**From:** Scala, Mary Joy  
**Sent:** Monday, August 29, 2016 3:15 PM  
**To:** Wolf, Fred  
**Cc:** 'gah@indacoriskadvisors.com'  
**Subject:** BAR Actions - 510 Locust Ave - August 16, 2016

**RE: Certificate of Appropriateness Application (Historic Conservation District)**

510 Locust Avenue

**CITY OF CHARLOTTESVILLE  
BOARD OF ARCHITECTURAL REVIEW  
STAFF REPORT  
August 16, 2016**

NORTH ELEVATION

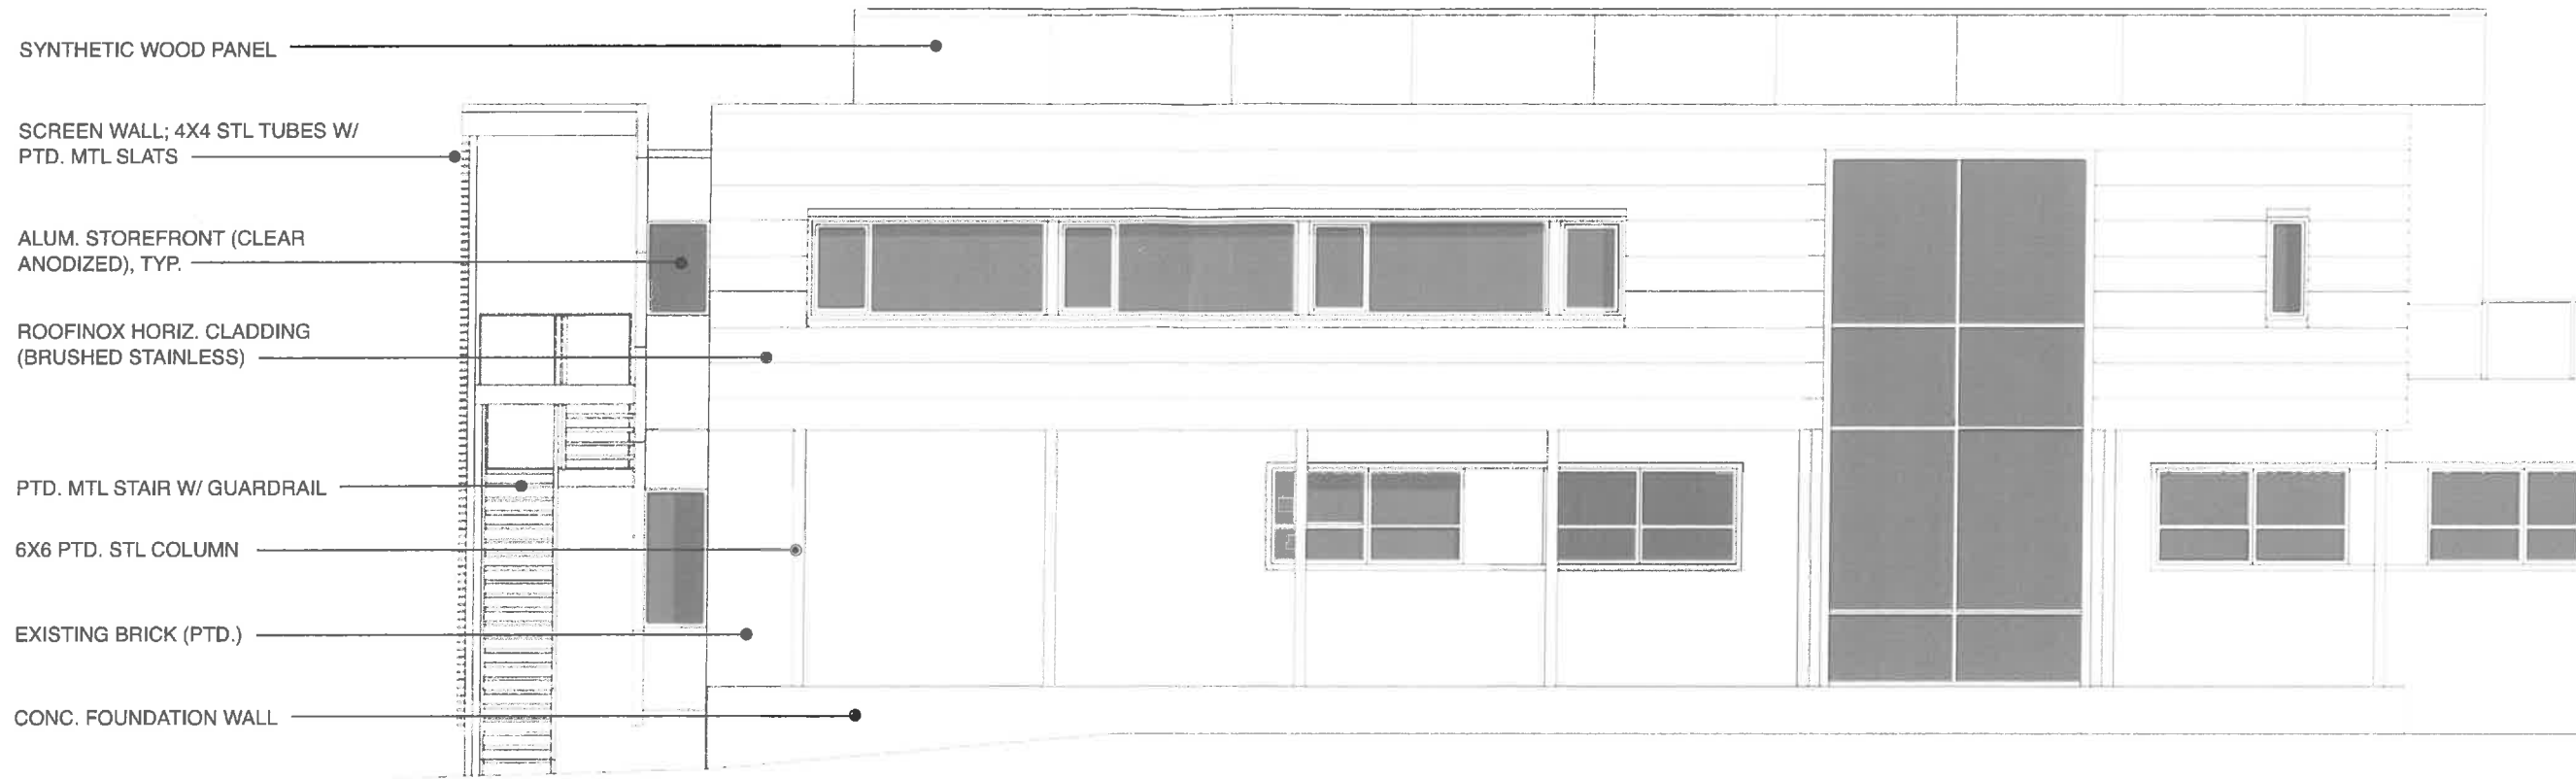
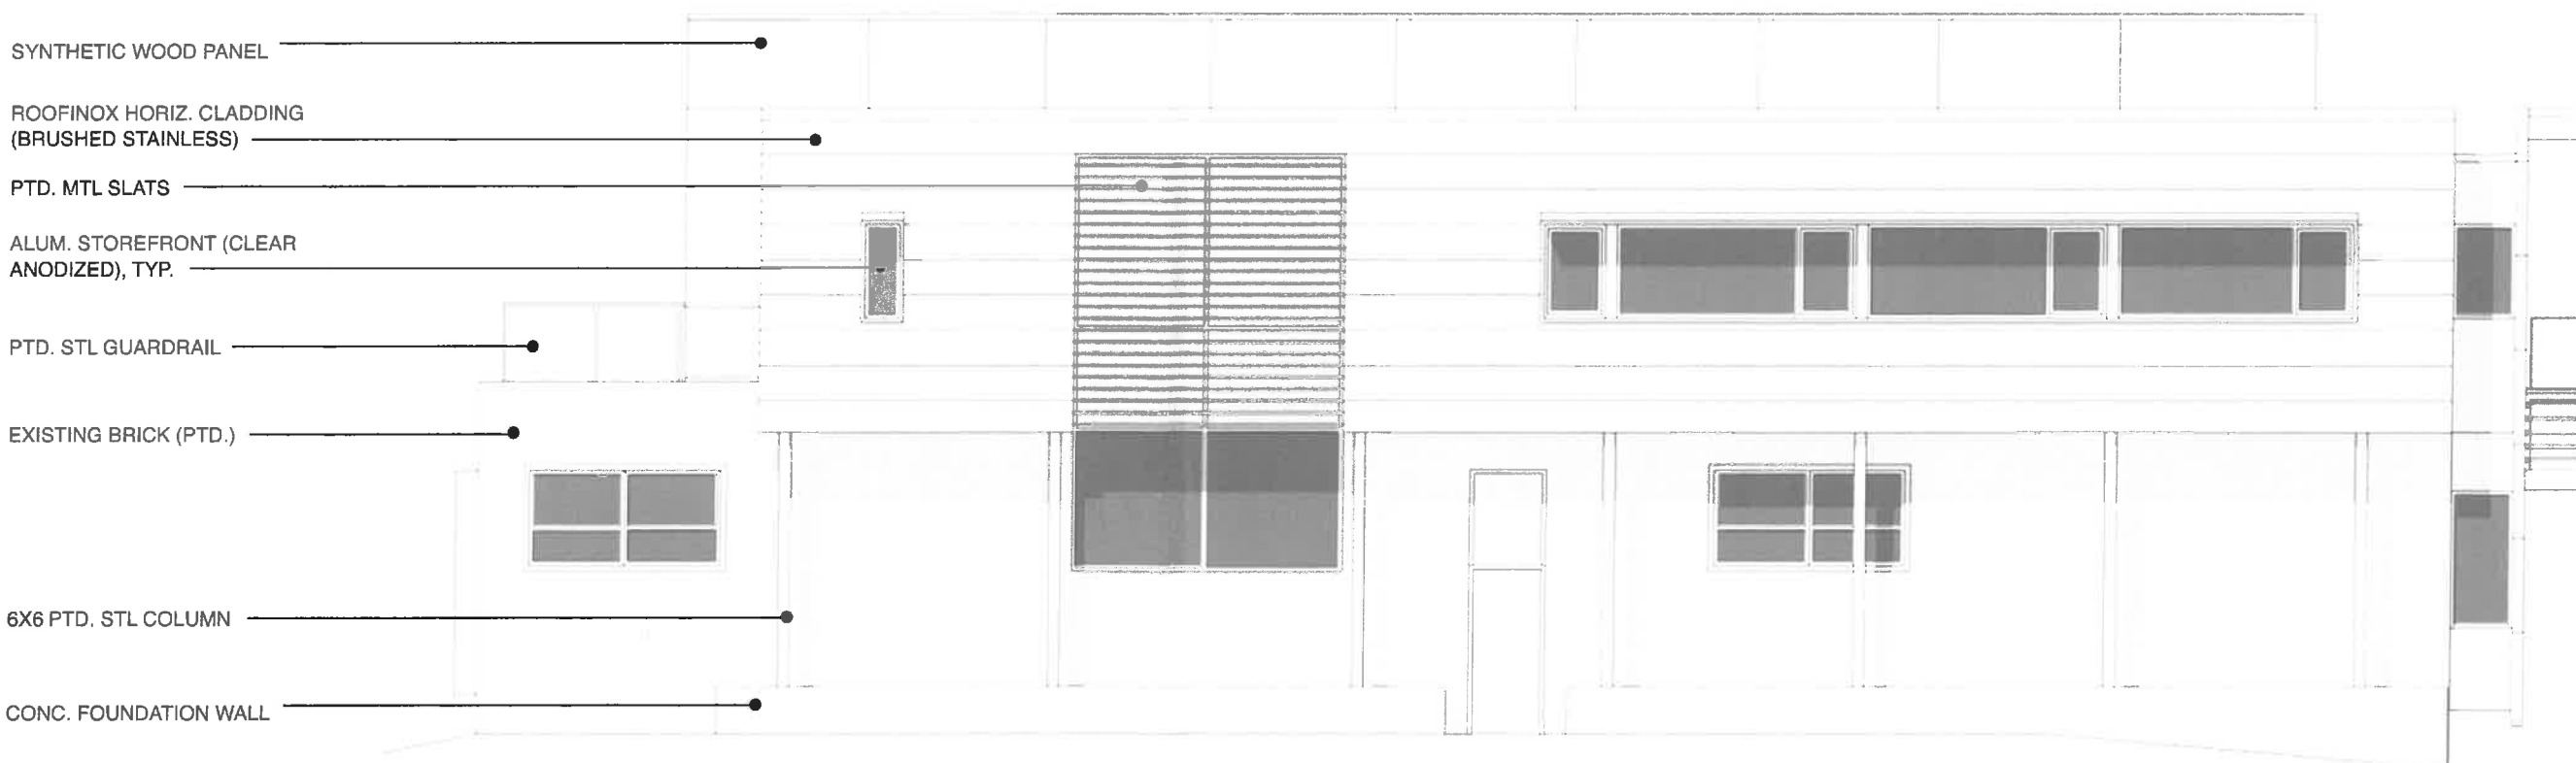
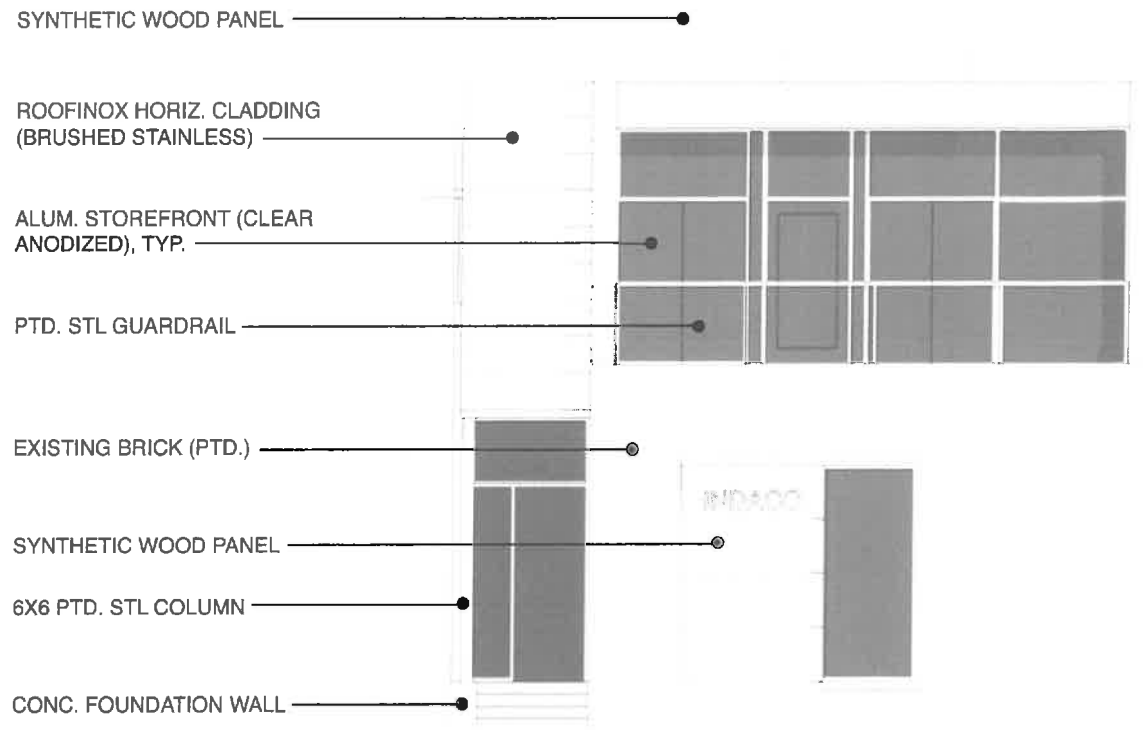
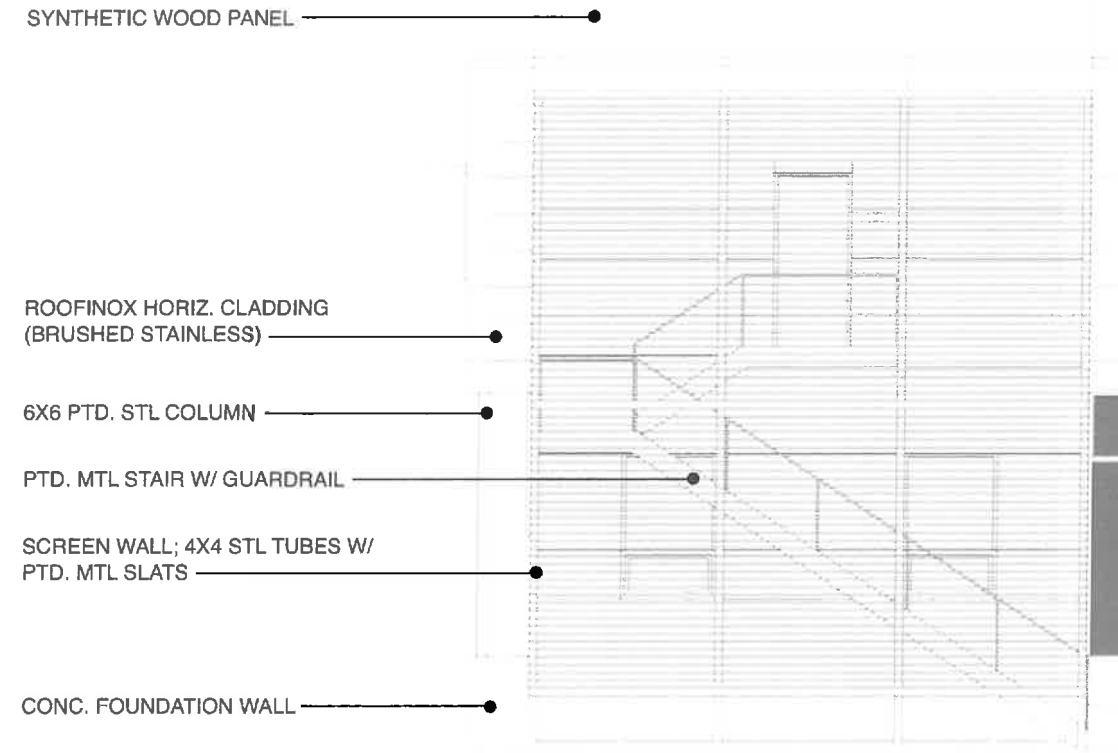
Do you have VLT and VLR specs for the proposed glass? (It should be clear).  
Are you changing the site plan at all? If so, can I get a copy of the site plan ( landscape plan)?  
Will you bring samples to the meeting? What brand is the synthetic wood?

All glass will be clear - I realize the rendering seems to show it tinted. That was because the model is just a shell and if the glass were rendered clear, it would look confusing. I don't have a spec though.

I will bring samples - the synthetic wood panels are by Parklex FYI (<http://www.parklex.com/usa/>).  
See you next week. Thanks,
